## Dixie-Narc

## Bulletin

All Serpentines

SUBJECT: Installation Instructions - Sign Panel Replacement.

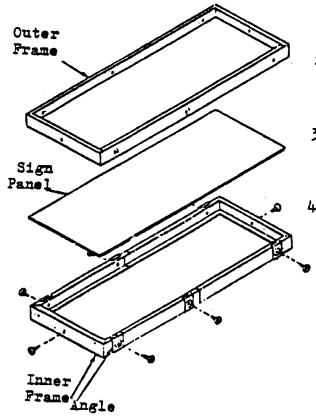
REASON: To provide an angle which permits the installation of the current sign panel.

KIT CONSISTS OF: 6 A164,010,150.03 Adaptor Angle, per sign face.

- Remove sign frame from vender. Disassemble frame and remove original sign panel.
- Tape 6 angles in place on inner frame, 2. aligning hole in angle with hole in frame. Short flange of angle should rest on top of frame as pictured.
- Set replacement panel on inner frame, 3. nesting between edges of angles at top and bottom, and flush with outside of frame at ends.
- Set outer frame in place and reassemble with original screws. Install sign in vender.
